R03GZ

Driver's Platform Rear Flange Bolts

MODELS AFFECTED: 1999 to 2004 All American Rear Engine (A3RE) and 1991 to 2004 TC/2000 Rear Engine (TCRE, T2RE) School Buses

RO3GZ
CAMPAIGN
RECALL

Bolt Locations

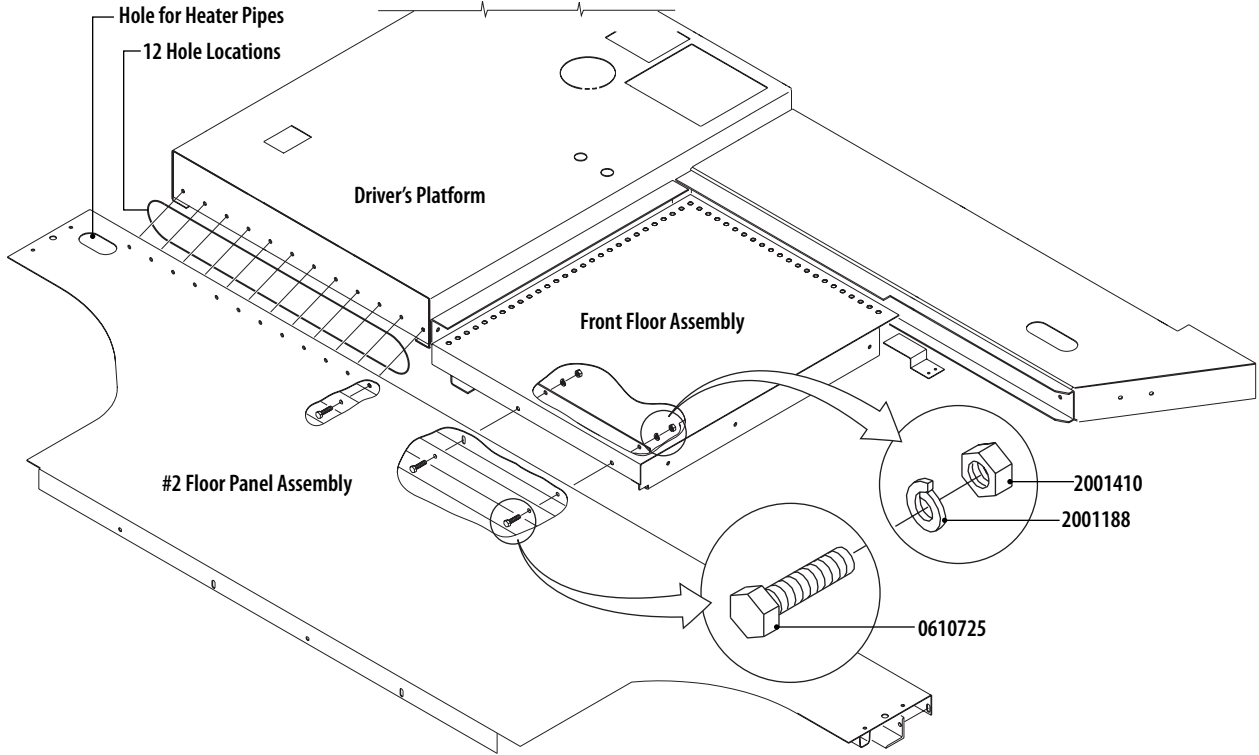
Bolts that attach the driver's platform rear flange to the body floor structure may not have been installed.

4 Inspect the floor joint between the Driver's Platform, the No. 2 Floor Assembly and the Front Floor Assembly for a total of fourteen (14) bolts. Twelve (12) bolts connect the Driver's Platform and the No. 2 Floor Panel Assembly. The remaining two (2) bolts connect the Front Floor Assembly and the No. 2 Floor Panel Assembly and can be accessed from between the frame rails. See "Bolt Locations" illustration on page 2.

5 If any bolts are missing, install bolts, lock washers, and nuts. Torque all bolts to 10 to 15 ft-lbs.

6 If the holes in the flanges on the floor panels do not line up, backdrill 11/32 (.344) diameter holes using existing holes as guides. Using a 90 degree angle drill is recommended.

Heater Pipe Passage Through No. 2 Floor Panel Assembly (Left Side of Bus)

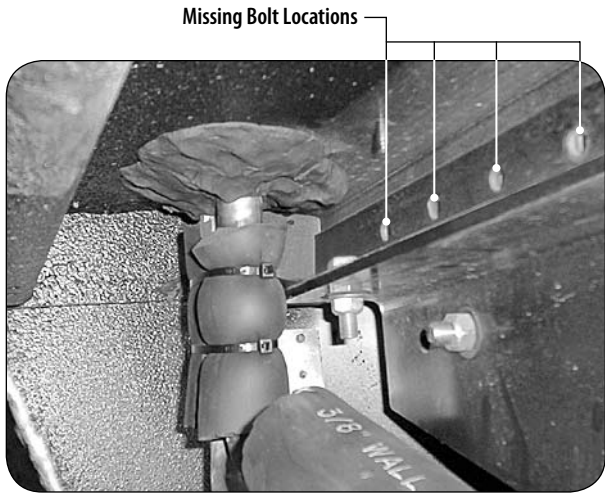
CAUTION Use a backing plate between the heater hoses and the body flange to prevent damage to heater pipes and hoses.
